Rear Infill

Proposed Section 73 Amendment

Summary of Changes

Cill Height

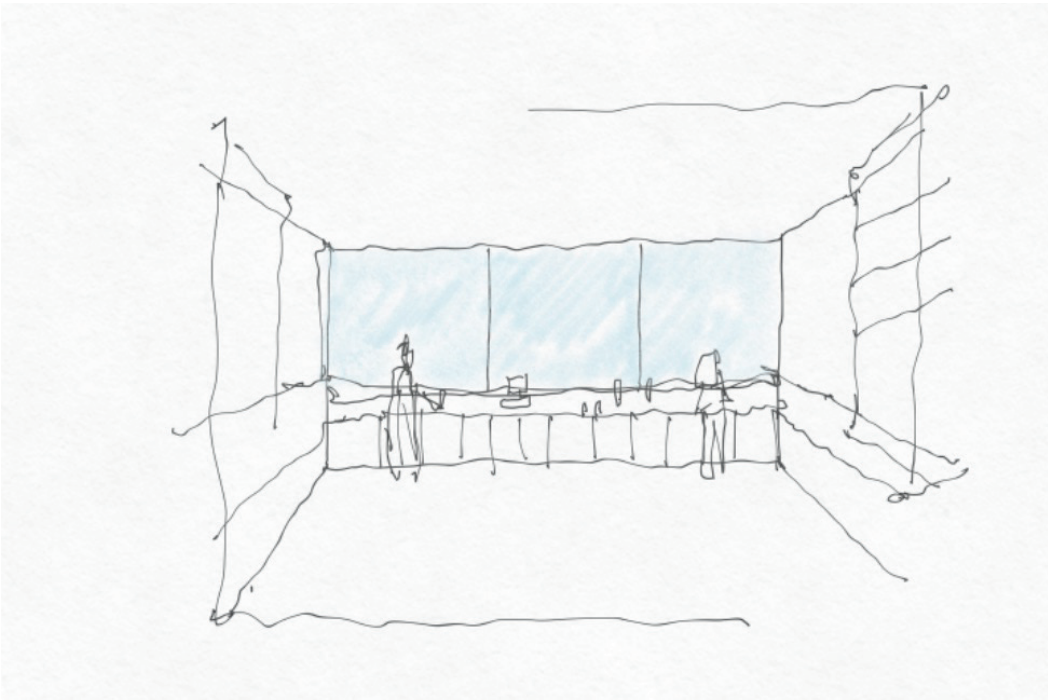
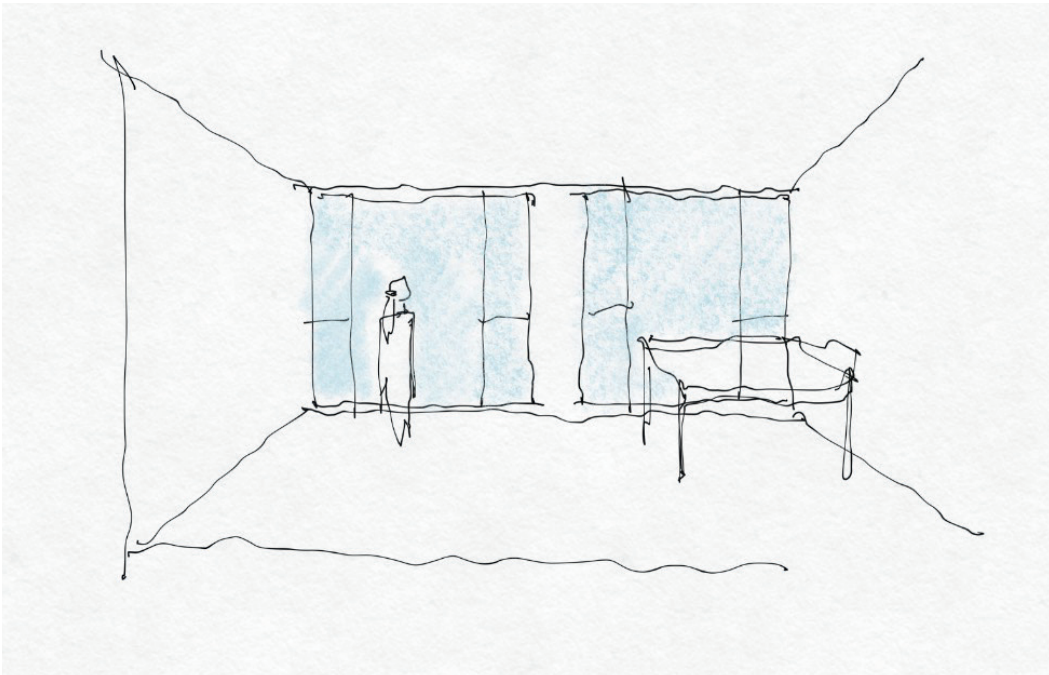
The proposals make adaptations to window openings to suit laboratory space planning and limit solar gain whilst maximising daylight.

Laboratories require specific environmental conditions which require significant servicing for balance and control. Equipment generates heat, therefore external factors such as solar gain should be limited where possible to reduce energy loading on servicing.

Proposals raise the cill height to match benching, significantly reducing glazing area across the facade. This allows flexibility in space planning for a range of laboratory layouts.

Window head height is maximised to preserve views out and provide good daylighting, reducing lighting loading.

Windows are proposed to be openable to allow flexibility for office retrofit in future.

Office Facade
Full height glazing
Glazing Ratio: 59%

Lab Facade
Bench height glazing
Glazing Ratio: 40%
